Value Engineering Study Report

Jefferson County I-264/US 42 Interchange and I-264 Widening
Item No. 5-804.00 and 5-594.00

Study Date: December 8-12, 2014

Figure 17: VE-1 Alternative Concept

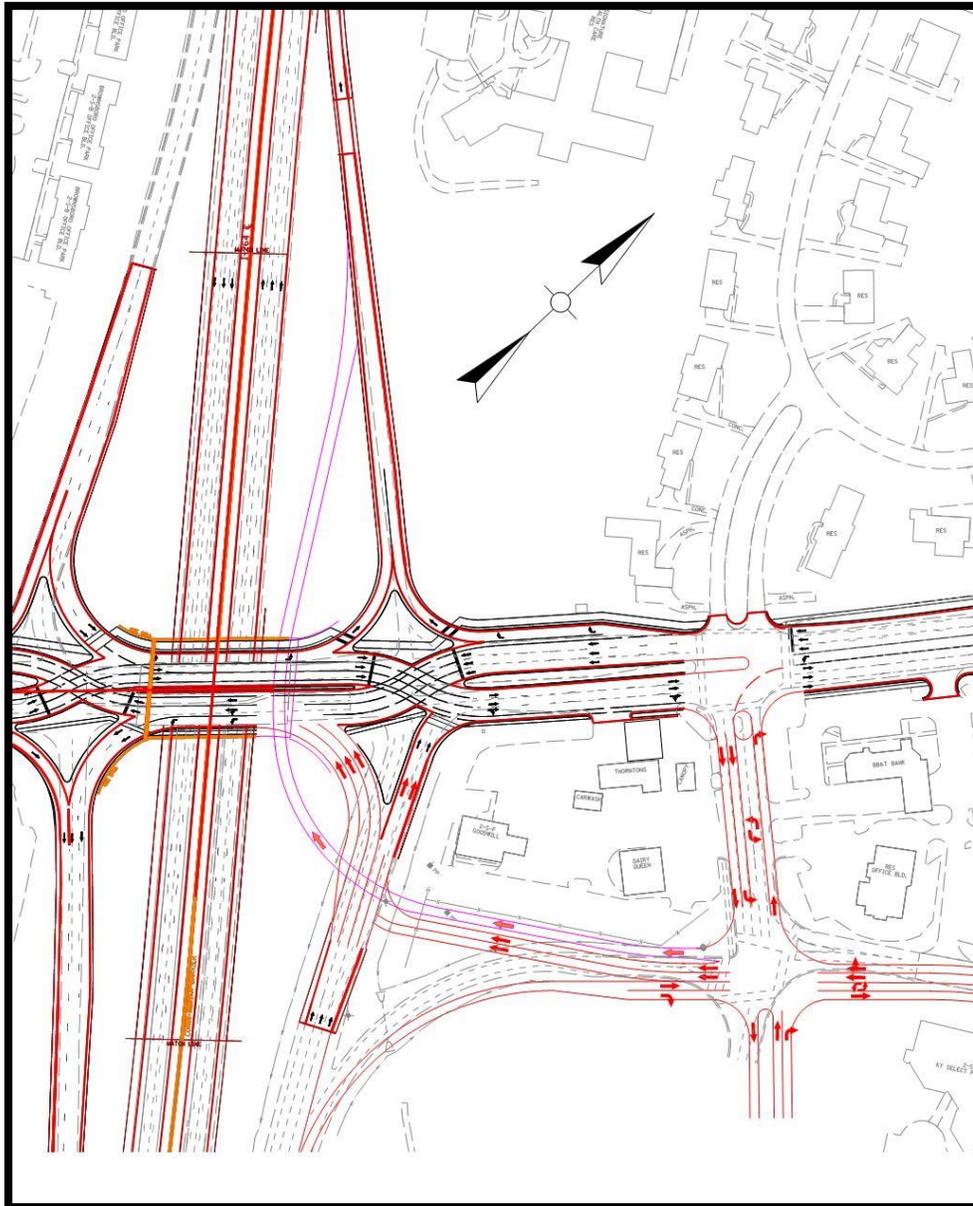
VE RECOMMENDATION VE-1 ALTERNATIVE 2 MODIFICATION		Idea No. 5		
Baseline				
The baseline design is a SPUI at the I-264/US 42 interchange and a full intersection at US 42/KY 22.				
Recommendation				
<p>The recommended design is a modification of Alternate 2 (Diverging Diamond Interchange (DDI)) which includes a six-lane DDI (three lanes each direction) on US 42, a full signalized intersection at US 42/KY 22 at its existing location, a six lane section on KY 22 from US 42 to the VA Hospital entrance including three inbound lanes and two outbound lanes and a two-way left turn lane (TWLTL), and a four lane section on KY 22 from the VA Hospital entrance to McDonalds including two lanes outbound to McDonalds, one lane inbound to VA intersection, and a TWLTL. The baseline maintains the slip ramp to KY 22 from the I-264 exit ramp.</p> <p>This recommendation is to modify the signal at the existing US 42/KY 22 intersection by eliminating the northbound through and northbound left turns. The northbound approach at the existing US 42/KY 22 intersection will be restricted to right turn only onto US 42. Right and left turns are provided from US 42 into KY 22 at the existing intersection. A new single lane connection from KY 22 to EB I-264 (toward I-71) is provided by passing below the EB I-264 exit ramp. A new two lane connection is provided from KY 22 to the EB I-264 exit ramp and adds a signal on the ramp. A third lane is added to EB I-264 exit ramp downstream of the new signal on the ramp to allow for traffic to move from KY 22 to WB I-264 on ramp. KY 22 from the VA access to McDonald's includes two lanes westbound from McDonald's to the VA intersection one lane eastbound to McDonald's, and a TWLTL.</p>

As shown in **Figure 17**, the alternative concept is based on the DDI interchange alternative previously developed by the design team. The recommendation is to simplify the existing US 42/KY 22 intersection. Traffic on KY 22 will access westbound US 42 and westbound I-264 via an extension of KY 22 to the I-264 eastbound exit ramp through a new signalized intersection. KY 22 traffic bound for eastbound I-264 (toward I-71) will access via a lane that passes below the eastbound I-264 exit ramp and merges onto I-264. A bridge and retaining walls will be required to pass KY 22 below the exit ramp. The intersection at the VA Hospital access and KY 22 will be signalized.

Figure 20: VE-3 Alternative Concept

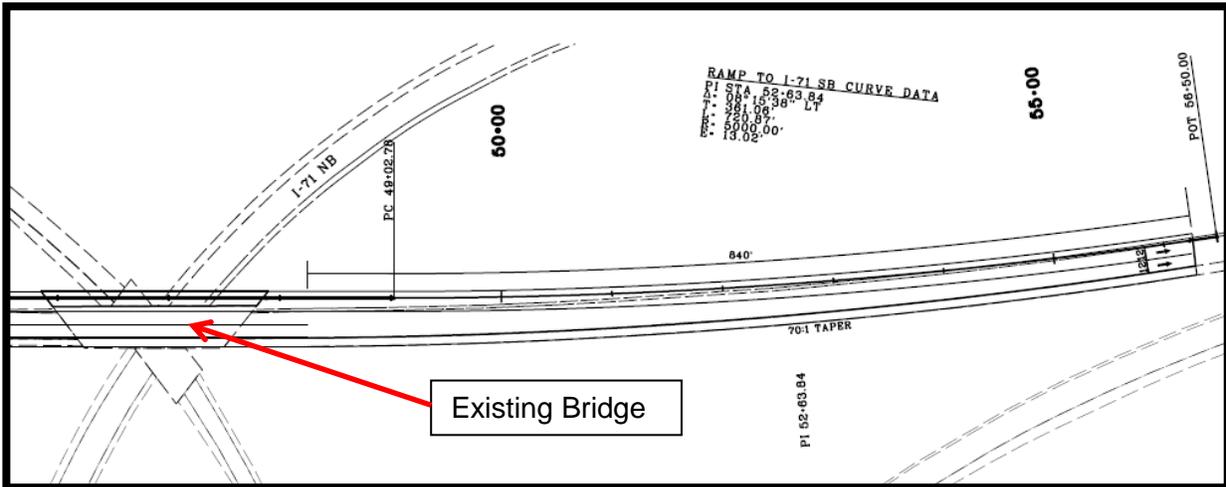
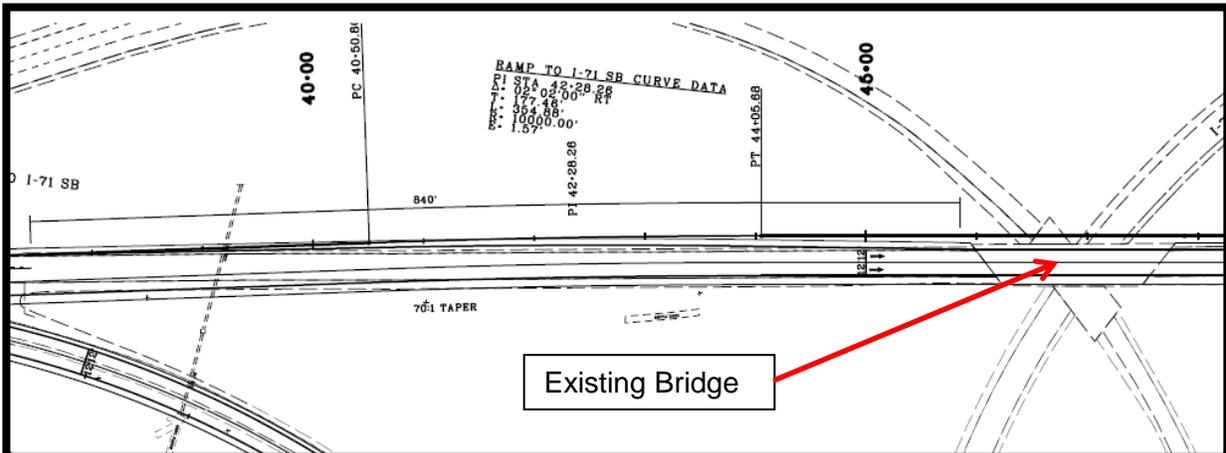
VE RECOMMENDATION VE-3 DROP THIRD THROUGH LANE ON I-264 AT THE SPLIT TO I-71		Idea No. 30		
Baseline				
The baseline concept maintains three lanes on eastbound I-264 to southbound I-71 past the bridge over NB I-71 and the SB I-71 ramp to WB I-264 before tapering down to two lanes at a rate of 70:1 over 840 FT. This requires widening the existing bridge.				
Recommendation				
The recommended concept recognizes that I-264 ends at the interchange and the roadway in question is a ramp and not a freeway mainline. The concept begins lane drop taper just after the EB ramp gore so that it ends just prior to the existing bridge (utilizing the same taper rate as the baseline). This concept allows the existing bridge to be maintained.				
<ul style="list-style-type: none"> • Eliminates need to widen eastbound I-264 to I-71 southbound bridge • Reduces roadway costs • Reduces potential for throw-away costs when I-71 Interchange is modified 		<ul style="list-style-type: none"> • Advanced warning of the lane reduction will overlap with the I-264 to I-71 northbound and southbound diverge signage

As shown in **Figure 19**, the current baseline concept is based on the eastbound I-264 to I-71 southbound ramp having three lanes maintained over the bridge and tapering down to two lanes at a rate of 70:1 over 840 FT.

As shown in **Figure 20**, the purpose of the recommendation is to begin the taper prior to the existing bridge to allow it to remain as is. This eliminates throw-away costs incurred, of widening the bridge, when the I-71 interchange is modified.

During the presentation, the Design Team indicated that the beginning point of the taper was based on MUTCD signing guidance. The VE Team's review of the MUTCD did not indicate any restrictions that would preclude moving the taper closer to the ramp gore.

Figure 21: VE-4 Alternative Concept

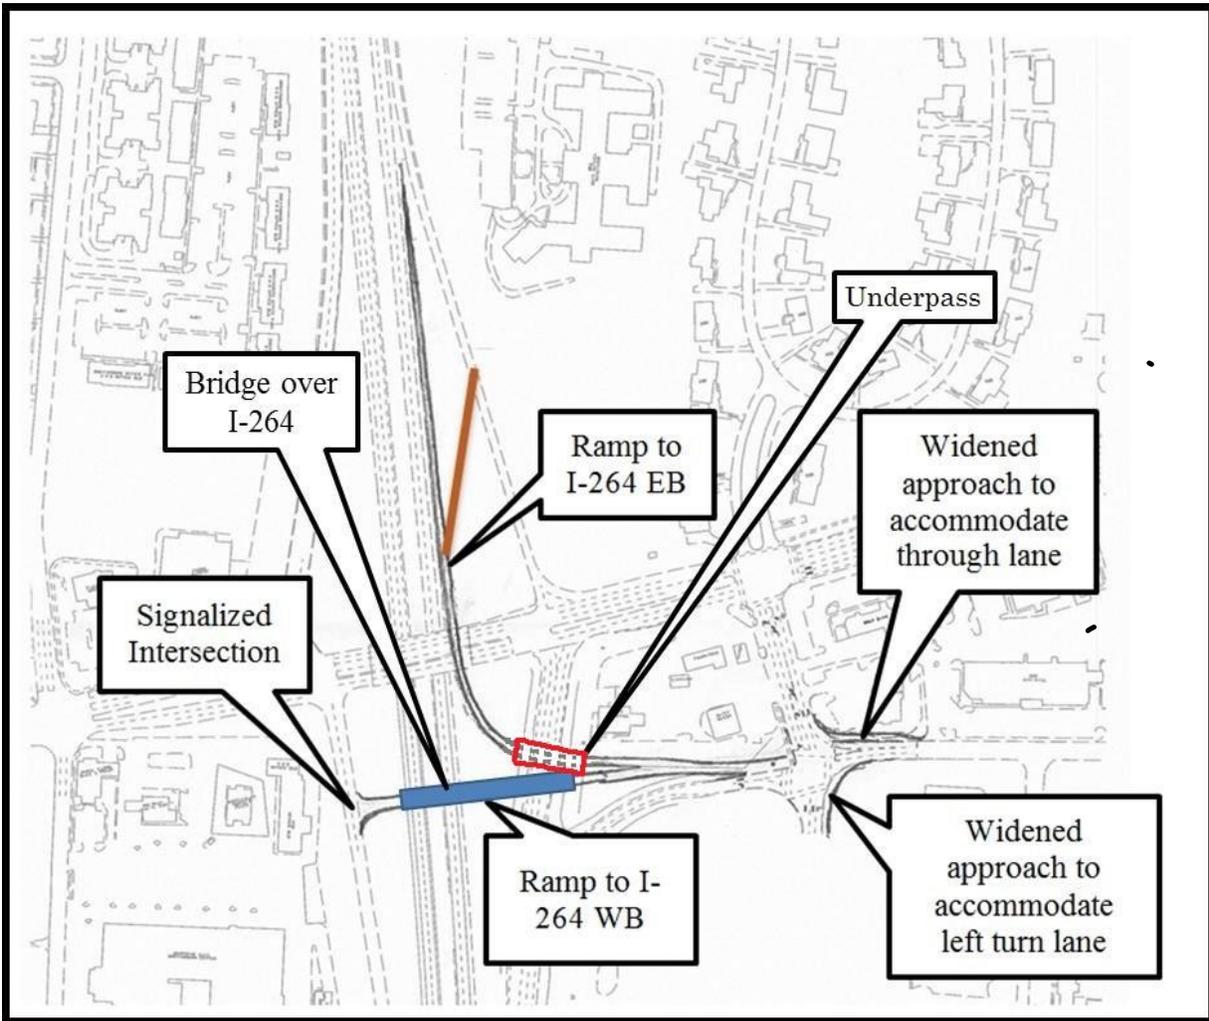
<p style="text-align: center;">VE RECOMMENDATION VE-4 CREATING EB & WB RAMPS FOR KY 22</p>	<p style="text-align: center;">Idea No. 36</p>
<p style="text-align: center;">Discussion/Sketches/Photos</p>	
<p>This recommendation can be considered as a “stand alone” alternative to the existing conditions or included with any of the other alternatives considered (SPUI or DDI). However, it is assumed that either a SPUI or a DDI will be constructed and costs are provided for each alternative. The NB and SB ramps are also independent – either or both could be provided. By providing direct access to I-264 for KY 22 and VA Hospital traffic, operations at both the US 42/KY 22 intersection and the I-264/US 42 ramp terminal intersections would be improved.</p> <p><u>EB I-264 On Ramp (toward I-71)</u> A proposed EB ramp meets the criteria for entrance ramp separation on I-264 (1,000 FT separation). A proposed EB ramp could either be designed as a “stand-alone” entrance ramp or as a CD road and tied into EB ramp from US 42. The stand-alone ramp is considered in this recommendation for cost purposes.</p> <p>Assumptions:</p> <ul style="list-style-type: none"> • The ramp would be constructed to go under the existing (or future) EB off-ramp from I-264 to US 42. A review of a conceptual profile indicates the ramp could be constructed with adequate clearance under the existing ramp with the use of MSE walls on both sides of the ramp. Since the off-ramp from EB I-264 is being rebuilt with all of the proposed alternatives, the off-ramp profile could be adjusted to provide additional clearance, if necessary. • In order to provide an additional through lane for KY 22 traffic desiring to utilize I-264, right-of-way (ROW) would be required from the tract on the NE corner of the KY 22/VA Hospital intersection. This ROW would likely require modifications to the existing building to eliminate the drive-thru for the fast food restaurant. • An additional left turn lane would be required for traffic coming out of the VA Hospital. It is assumed these modifications to the proposed plan for the VA Hospital could be easily accommodated and would not require any additional cost to the US 42 project. • Costs are provided for MSE walls although it is possible they may not be needed due to the existing rock conditions. <p><u>WB I-264 On Ramp</u> Assumptions:</p> <ul style="list-style-type: none"> • The proposed ramp from KY 22 to WB I-264 would be constructed to go over the existing (or future) EB off-ramp from I-264 to US 42 and over mainline I-264. Additional MSE walls would also be required due to the close proximity of the two ramps from KY 22 to EB and WB ramps (and the existing slip ramp from EB I-264). • Due to the proximity of this connection to US 42 and the volumes involved, a preliminary evaluation indicates this intersection will require signalization. In order to minimize impact with the signal on US 42, coordination would be required. If this recommendation is considered, the possibility of merging this traffic directly with the WB on-ramp (instead of using a signalized intersection) should be evaluated though there may be issues tapering away the add lane prior to entering westbound I-264.

Figure 22: VE-5 Alternative Concept

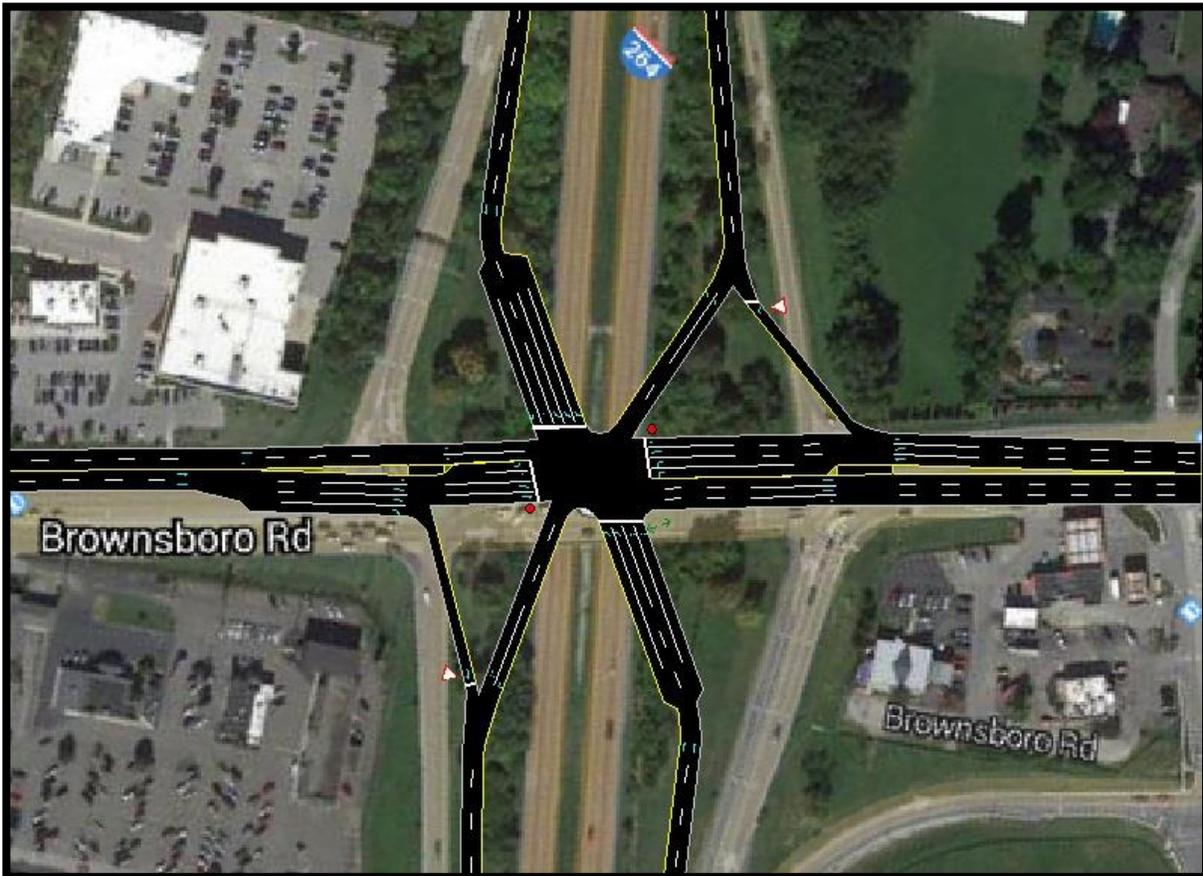
VE RECOMMENDATION VE-5 MODIFIED SPUI DESIGN		Idea No. 37		
Baseline				
Single Point Urban Interchange (SPUI) with triple WB left turn lanes and dual left turn lanes for the other left turns.				
Recommendation				
Single Point Urban Interchange with triple southbound left turn lanes (from the westbound I-264 exit ramp) and dual left turn lanes for the all other left turns. A third eastbound receiving lane on US 42 would be added to accommodate the southbound lefts. The additional lane would be dropped at the KY 22 intersection as a dedicated right turn lane.				
Advantages		Disadvantages		
<ul style="list-style-type: none"> Improves operational efficiency of the interchange by providing additional storage on the southbound left turn movement Eliminates triple left turn lanes from WB LT to the WB I-264 on ramp reducing merging issues on the ramp 		<ul style="list-style-type: none"> Does not address failure at US 42/KY 22 intersection

Note that while this does improve the flow at the SPUI slightly, this recommendation does not address the failure of the intersection at US 42 and KY 22 which will still result in the failure of the corridor. When analyzed in isolation, this recommendation slightly improves the SPUI by increasing the departing throughput eastbound on US 42. Within the overall network, there is no net effect as the critical component of the corridor is left unaddressed.

Figure 23: Design Consideration - Idea No. 17

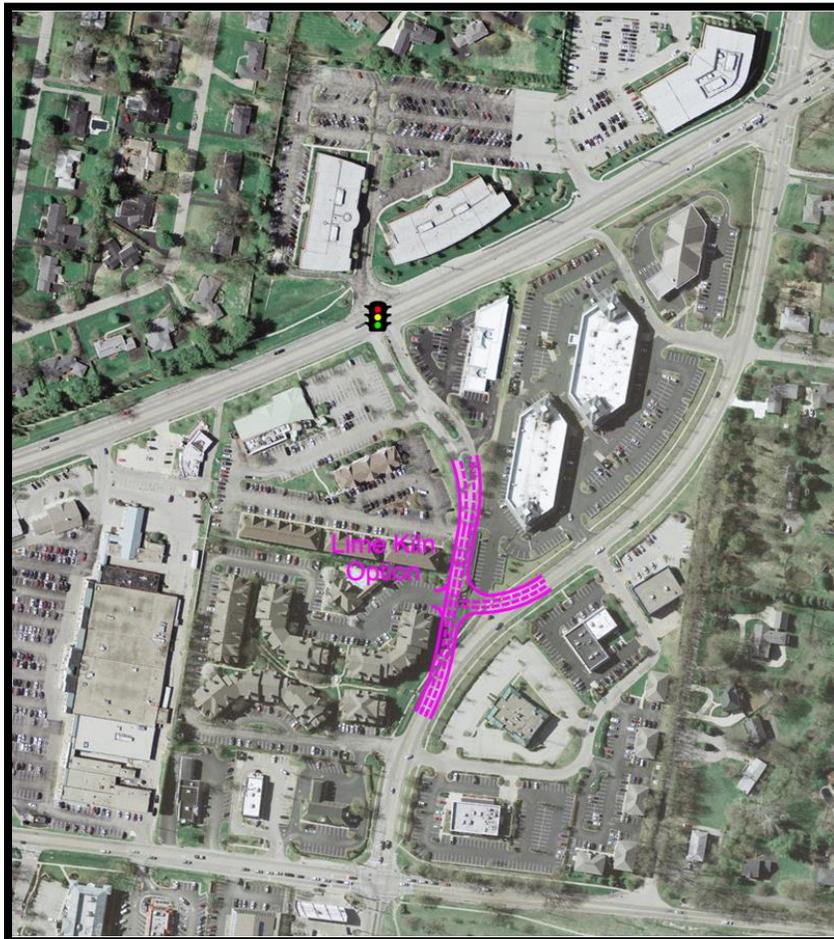
Idea-17: Extend Glen Eagle Drive to meet KY 22 at Lime Kiln Lane - One option for connecting KY 22 to US 42 is to extend Glen Eagle Drive to meet KY 22 at Lime Kiln Lane. This option would redirect some of the traffic currently using the US 42/KY 22 intersection. The redistribution of the traffic to two intersections would help to alleviate some of the left turning traffic at the existing US 42/KY 22 intersection and will improve the overall network.

Figure 24: Design Consideration – Idea No. 31

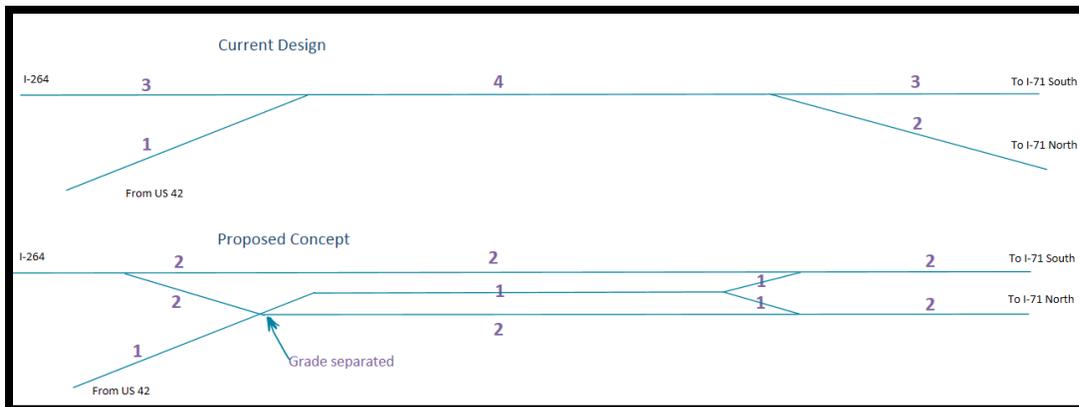
Idea No. 31 - Asymmetric partially splintered DDI - Move the diverge point for the I-71 interchange to the minimum distance downstream of the EB I-264 exit gore to US 42. This will put the I-71 diverge point, somewhere beneath the US 42 bridge (this will require lengthening of the eastern span). Braid the US 42 entrance ramp to EB I-264 over one of the ramps to I-71 and land the entrance ramp from US 42 between the two ramps to I-71. Allow a split on the US 42 entrance ramp right and left to allow access from US 42 to either I-71 ramp. This concept provides full access to either direction of I-71 and eliminates the weave entirely. The concept will also be compatible with future system improvements including the switching of right/left to the different directions of I-71.

Figure 25: Design Consideration – Idea No. 35

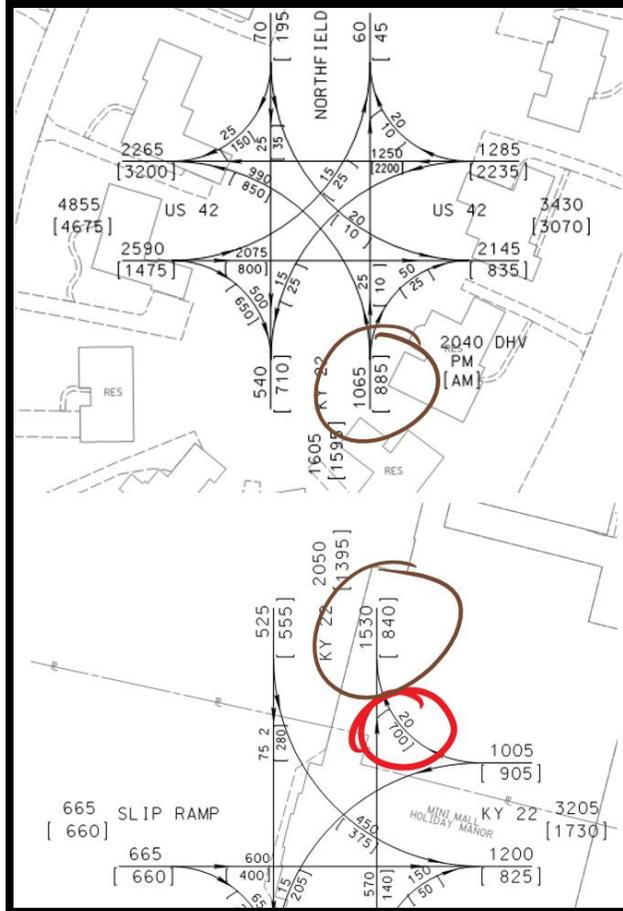
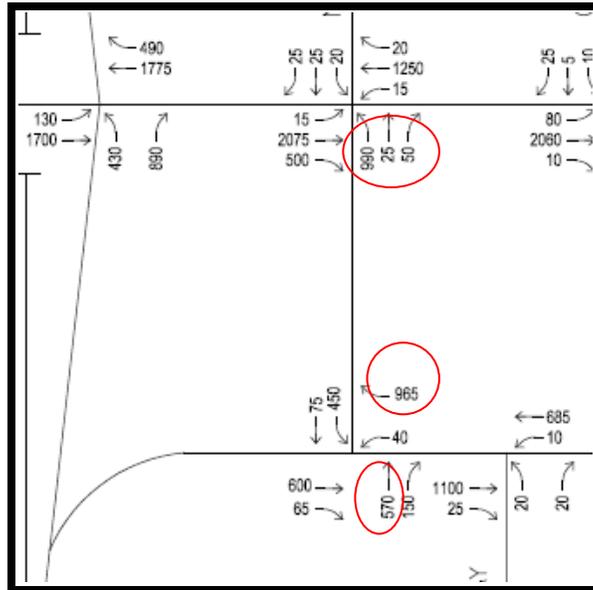
Idea No. 35 - Undertake a review (either internal or external) of the VISSIM Modelling for the 2040 through traffic volumes from the VA site to the US 42 @ KY 22 intersection - The VE Team recommends revisiting the volume balancing that occurred during the post processing of the travel demand model. The critical element within the project area is the intersection of US 42 and KY 22. The most critical movement at this intersection is the south approach of the US 42/KY 22 intersection.

There is a significant disparity in the volume NB on KY 22. The south leg at US 42 has 465 vph less than the north leg of the KY 22/Slip ramp intersection. While we recognize that these volumes need not match exactly, the significant drop in NB traffic on such a short segment should be revisited. See **Figures 25 & 26**. It appears likely that the traffic exiting the VA site heading NB was not added into the volume at US 42/KY 22. We suspect that the WBR at the KY 22/Slip Ramp intersection has a typographical error and the 20 vph should be 990 vph. This correction does not impact the earlier statement.

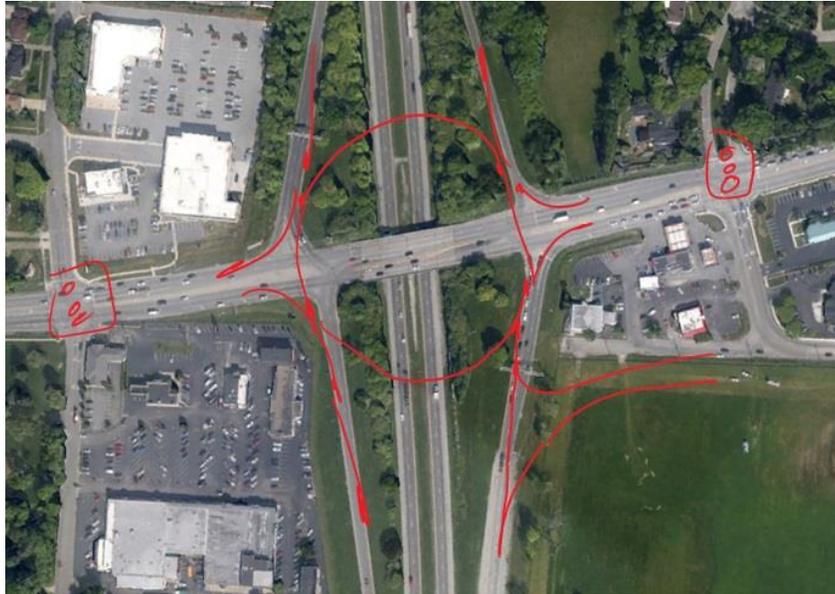
This idea cannot be accomplished geometrically.

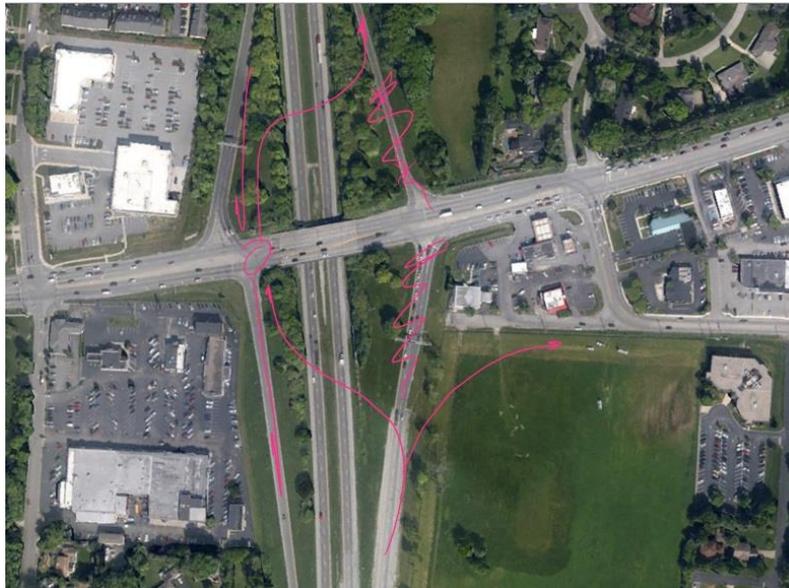
Operational this may be slightly better than the base case but there would be a significant increase in maintainability and construction costs due to the increase in the number of bridges.
